PROJECT REVIEW COMMITTEE - CITY OF WILDWOOD
PRC Chairperson – Melanie Strickland

Agenda
Regular Meeting
May 13, 2025 10:00 AM
Commission Conference Room 124
100 N Main Street

SUBJECT: SP 2407-005 Wildwood Oaks Master Plan - Mass Grading

SANITARY UTILITY PLAN FOR WILDWOOD OAKS MASTERPLAN

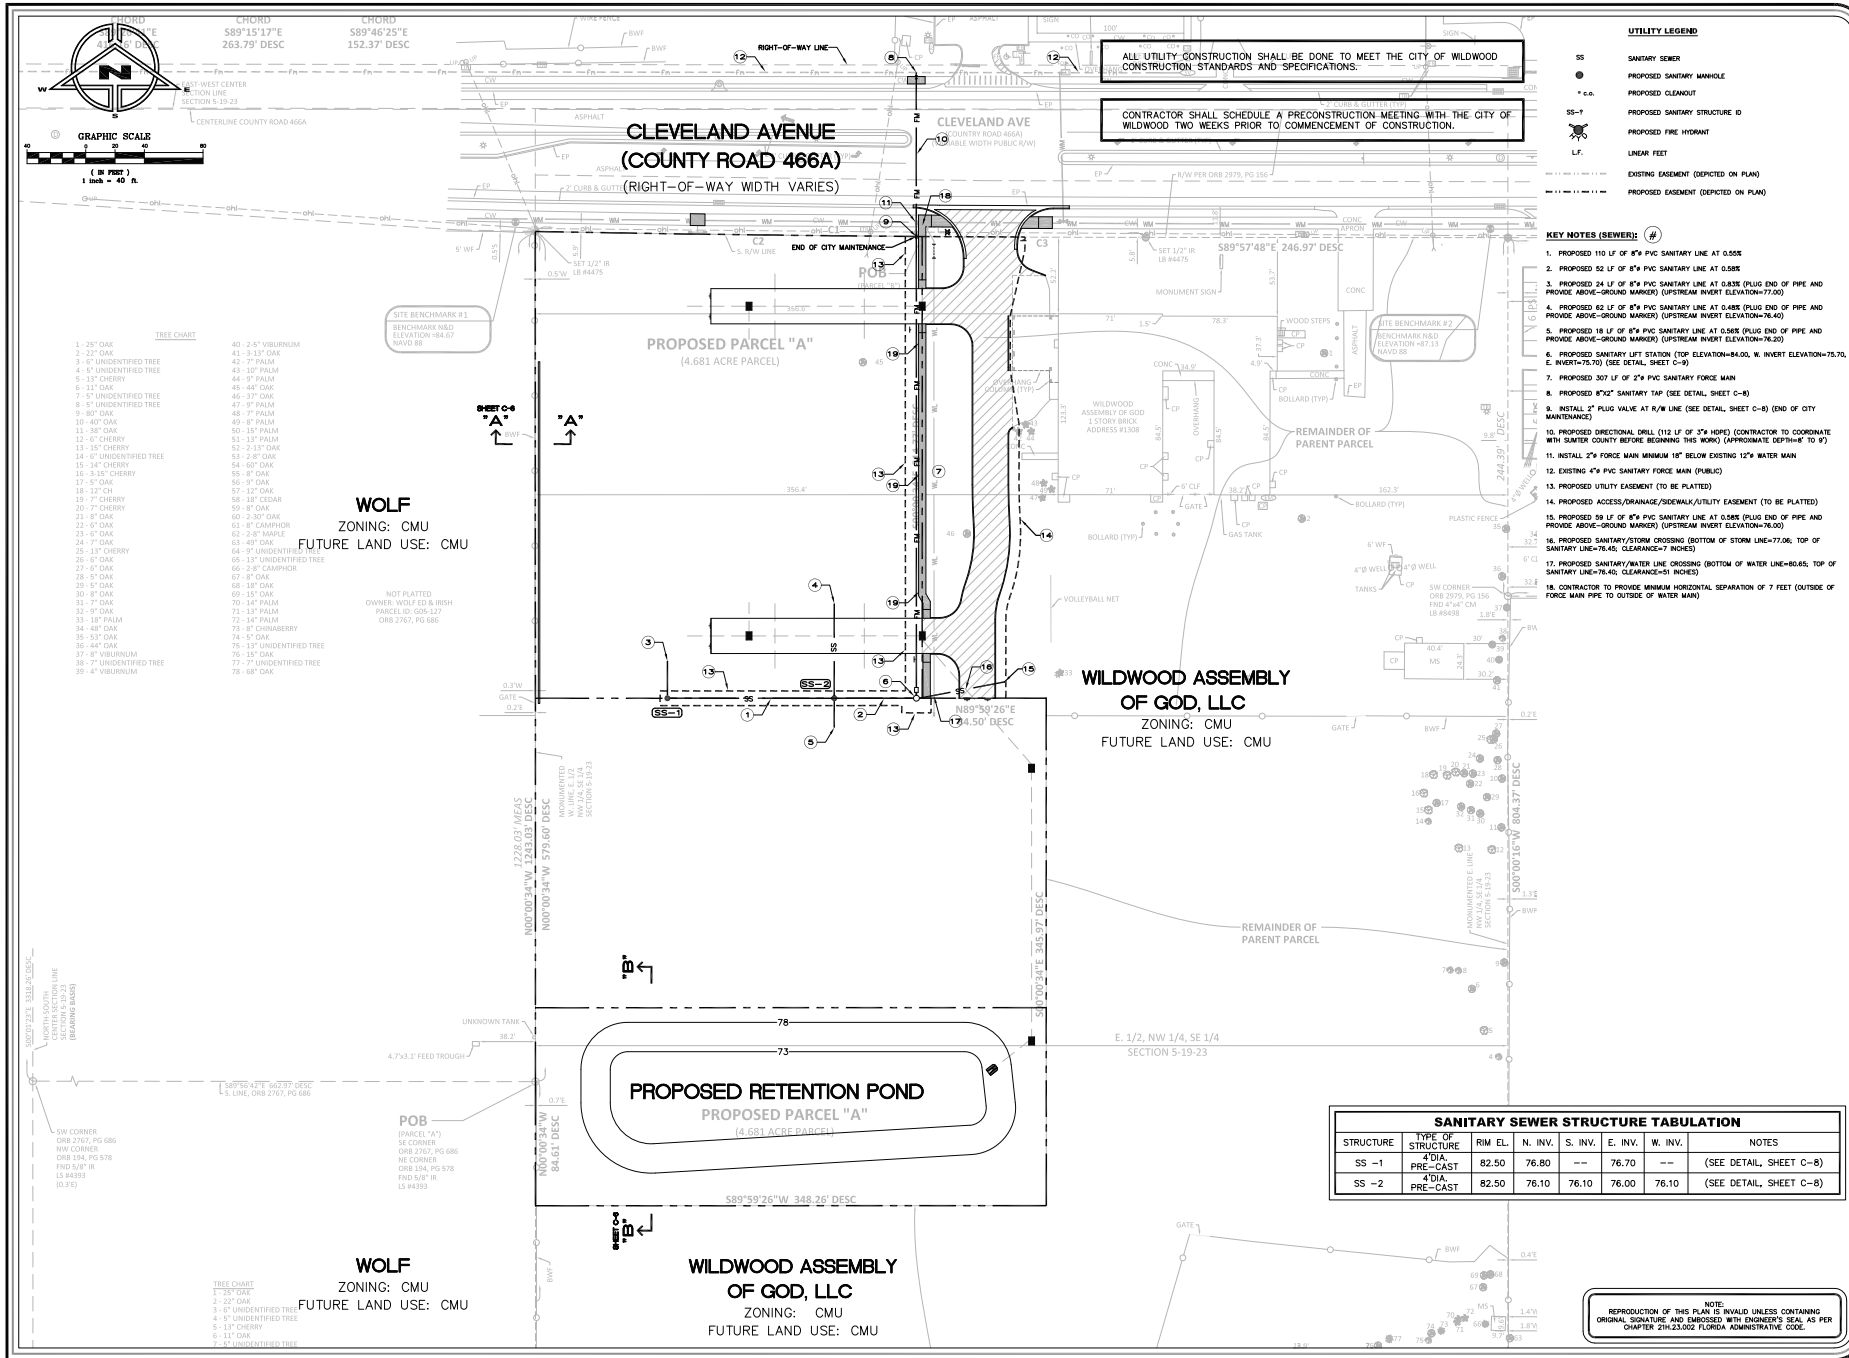
1. LDR 4.4(C)(9) – Please add notes showing where the end of City maintenance of water and sewer will be on sheets C-4 and C-5.
 - A. Please see revised plans (sheets C-4 and C-5). The “End of City Maintenance” notes have been provided.

- a. Please see revised plans (sheet C-4). A proposed public utility easement has been shown.
 - i. Please submit a utility easement application.
 - a) **Per our discussion, it is our intention for all proposed utility easements to be dedicated via the plat.**

- i) **Response acknowledged; Standing comment.**
2. LDR4.4(D)(6) – Please provide copies of all proposed or executed easements for cross-access, water and wastewater utilities, shared stormwater facilities, or other required easements.

- I. Response acknowledged; comment remains until satisfied.
 - a. A copy of the draft Declaration has been uploaded as part of this resubmittal.
 - i. Response Acknowledged; Comment remains until copies of all proposed or executed easements are provided including the purposed easement referenced in comment # 1.

- a. **This comment has been noted.**
 - i) **Acknowledged; Standing comment.**
3. LDR4.4(E)(1) - Please provide a surety for performance bond if applicable.
